# Conceptual Review Agenda

Schedule for 05/16/16 to 05/16/16

# Evergreen Park Office and Vehicle Minor Repair

**PRELIMINARY SITE PLAN**

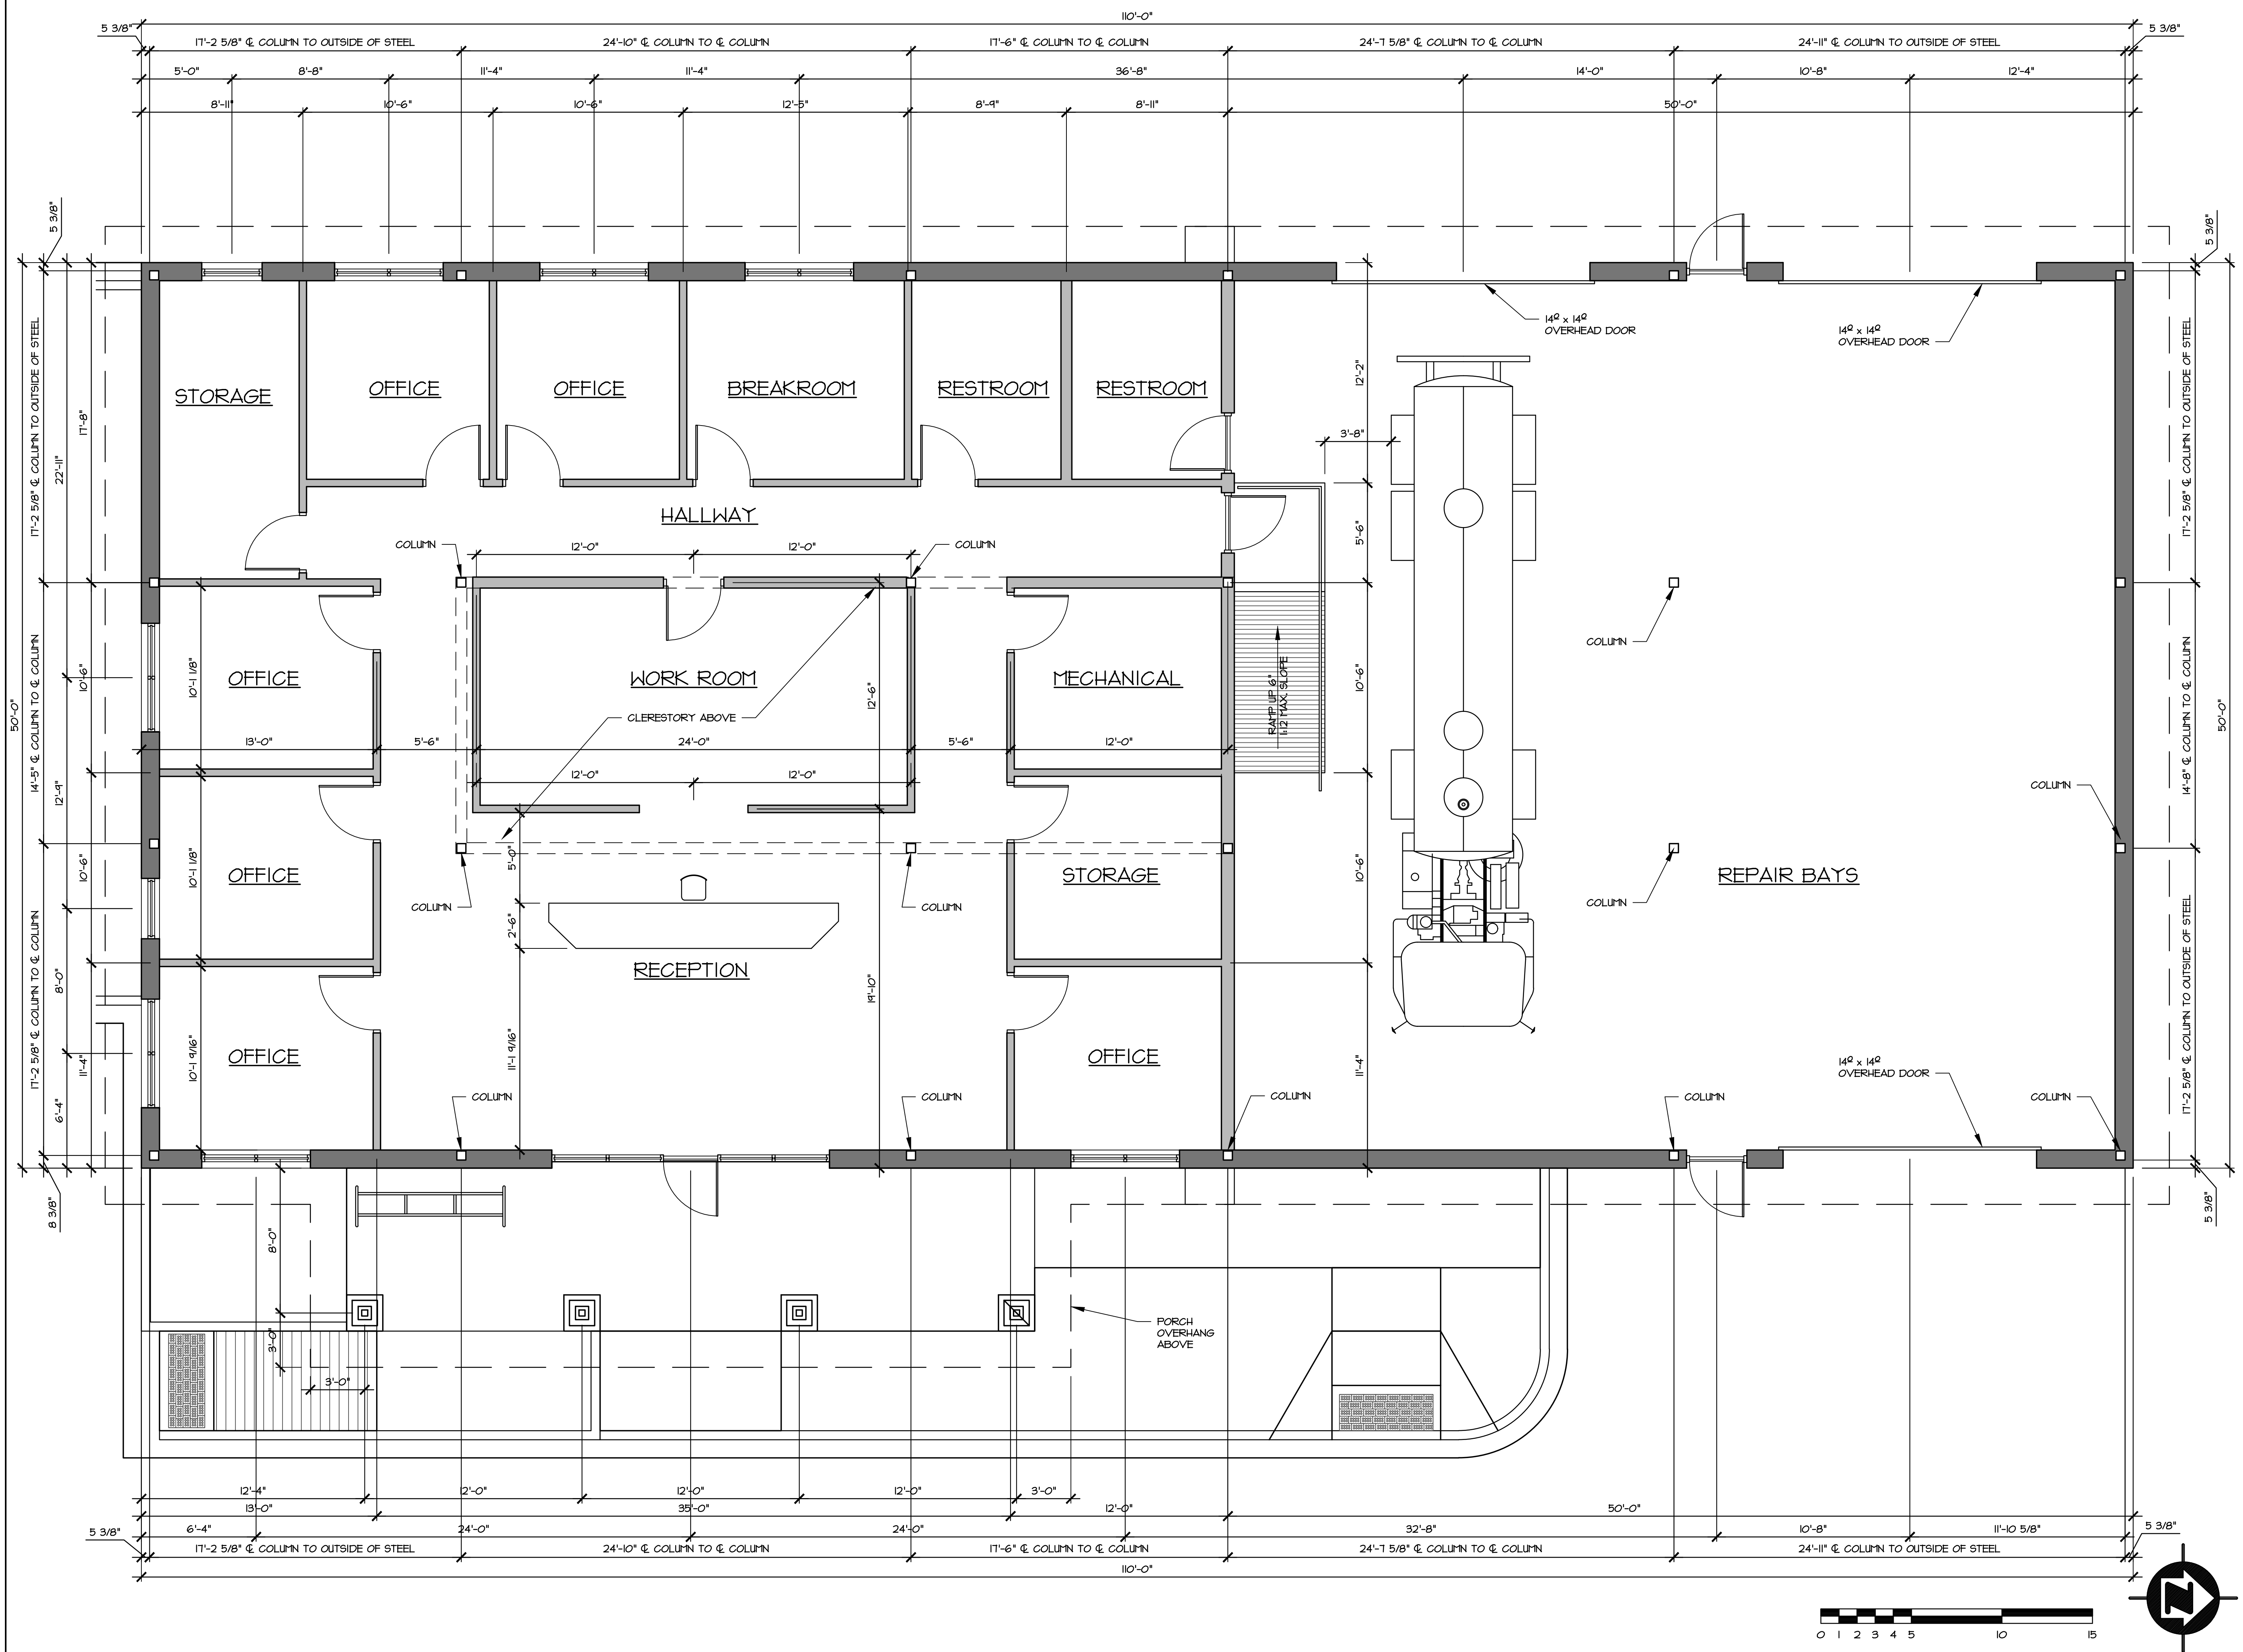
1. The anticipated change in traffic volume is not expected to rise to the threshold of needing a TIS. Based on section 4.2.3.D of LCUASS, the Traffic Impact Study requirement can be waived.
2. The frontage improvements as shown along Red Cedar look great!

8. Show sidewalk improvements to the north and how the sidewalk will connect to the existing infrastructure.
9. Utility plans will be required and a Development Agreement will be recorded once the project is finalized.

3. The site plan shows a connection to Lot 14 to the north. What is this planned connection for?
4. For your landscape plan, please look at the recent submittal from Raw Urth Designs. Staff would like a similar species mix to create a consistent look and feel to the district. Staff can provide you with a copy of this submittal.

**28' ALLEY SECTION**

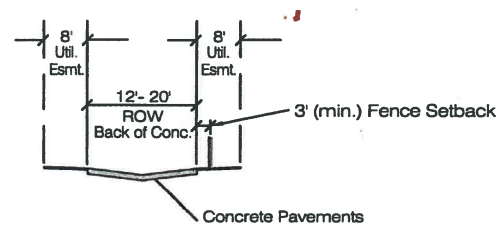
7. The plans show the use of narrow residential streets and public alleys. Neither of these would be allowed under LCUASS. If developed as public streets, these would need to be 36 feet in width in accordance with our connector local standards (due to multi-family projects requiring the larger street width). Rear access roadways that function as alleys would need to be private.

- 25.** The alley cross-section indicates an eight-foot wide utility easement on either side but this detail is derived from LCUASS Figures 7-11(F) and 7-12(F) as if the alleys are public and this cross-section assumes the units will front on a public street. As noted, the alleys will be private and the units will front on the "central green" not a public street.
